Office Action Summary

10/594,849

DETAILED ACTION

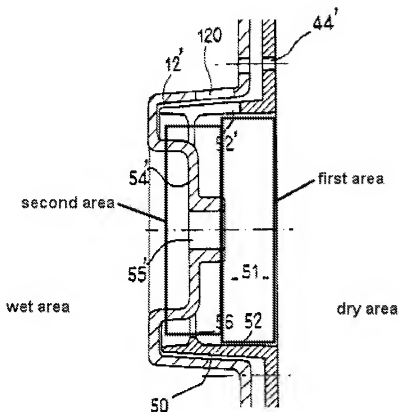
6. **Claims 1-3, 5, 6, 8-13 and 15 are rejected under 35 U.S.C. 102(b) as being anticipated by Velthaus et al. (US 6,574,922).**
7. Velthaus discloses a drum housing comprising: a mounting area having integrally formed side walls and a back wall; a first area of the mounting area having a first

diameter; a second area of the mounting area having a second diameter as shown in the figure below; and a thrust bearing 54' integrally formed on the back wall aligned with the first and second areas, as shown below. Examiner notes that no cable drum has been claimed, and the diameters of the first and second areas are sufficient for mounting a cable drum which has been properly sized to fit within the areas.

11. Regarding **claim 6**, the first diameter is greater than the second diameter as shown in the figure below.
12. Regarding **claim 8**, Velthaus discloses a door module comprising: a carrier part 20; a drum housing mounting area having integrally formed side walls and a back wall; a first area of the mounting area having a first diameter; a second area of the mounting area having a second diameter as shown in the figure below; and a thrust bearing 54' integrally formed on the back wall aligned with the first and second areas, as shown below. Examiner notes that no cable drum has been claimed, and the diameters of the first and second areas are sufficient for mounting a cable drum which has been properly sized to fit within the areas.

14. Regarding **claim 10**, fastening elements 42 are shown in Fig. 2.
15. Regarding **claims 11 and 12**, the carrier part divides the door interior into a wet area and a dry area as shown in the figure above, and the second area faces the wet area.
16. Regarding **claim 13**, the first diameter is greater than the second diameter as shown in the figure above.
17. Regarding **claim 15**, Velthaus discloses a door of a motor vehicle comprising: a door module (Fig. 1); a drum housing 50 having a mounting area having integrally formed side walls and a back wall; a first area of the mounting area having a first diameter; a second area of the mounting area having a second diameter as shown in the figure above; and a thrust bearing 54' integrally formed on the back wall aligned with
